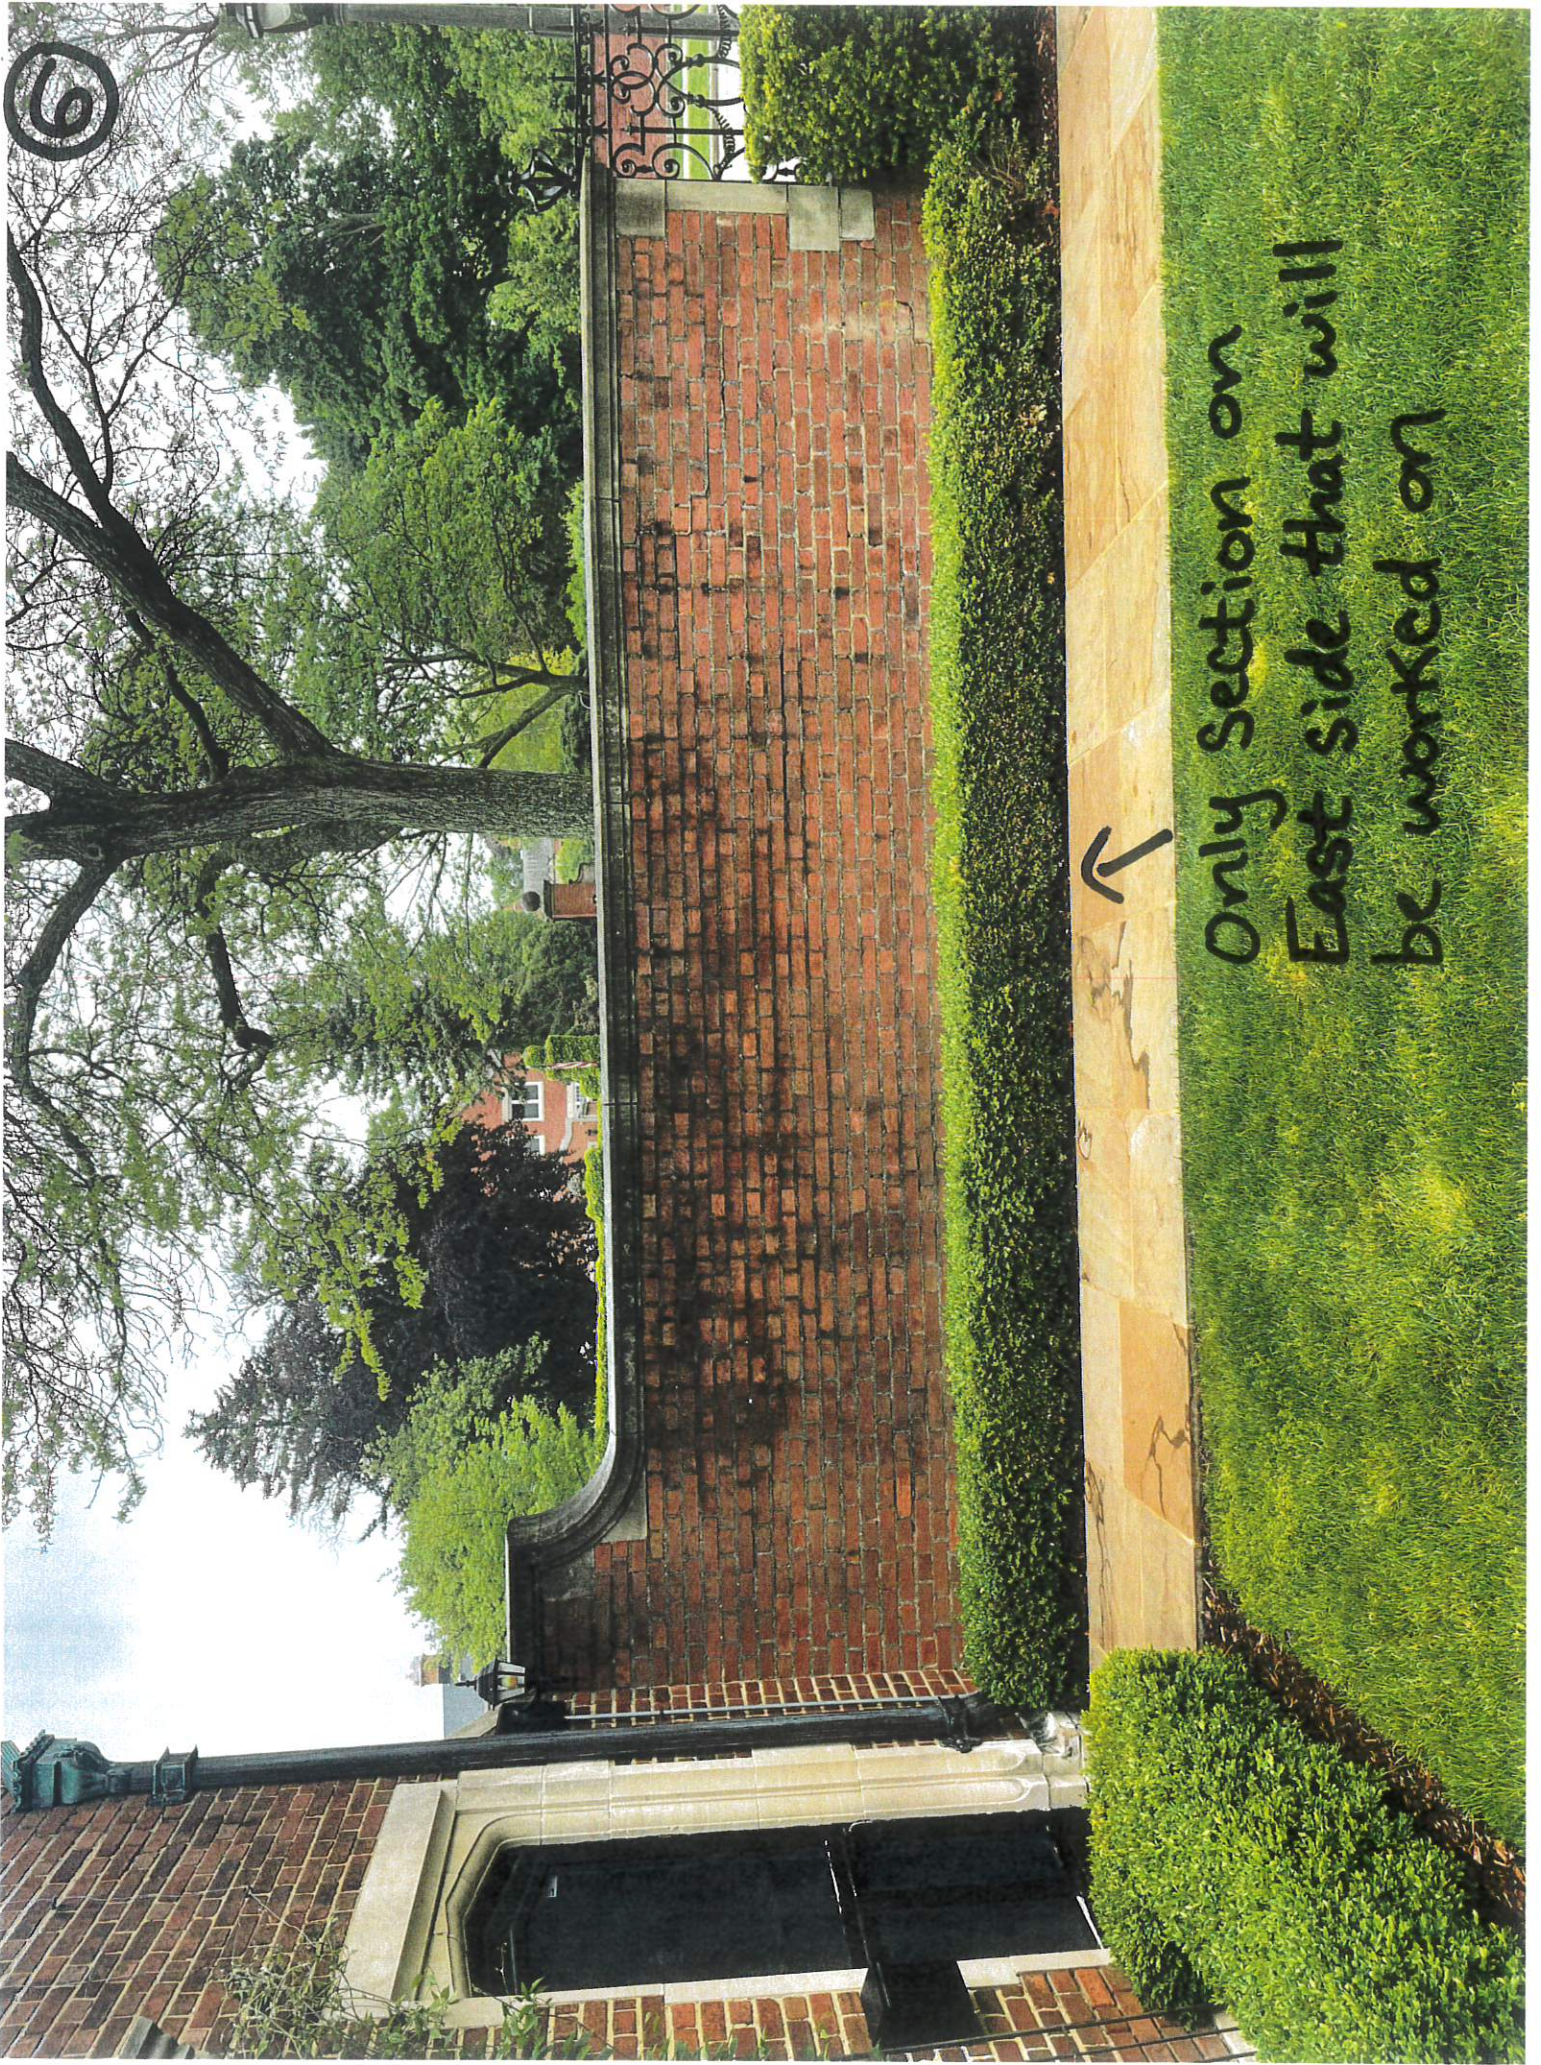
Two shifted copings shall
be relayed

Brick shall
be "toothed →
out" & relayed

Brick to
be relayed

Brick to be removed & blended as best as possible to remove "Bulge" in wall

Only section on
East side that will
be worked on
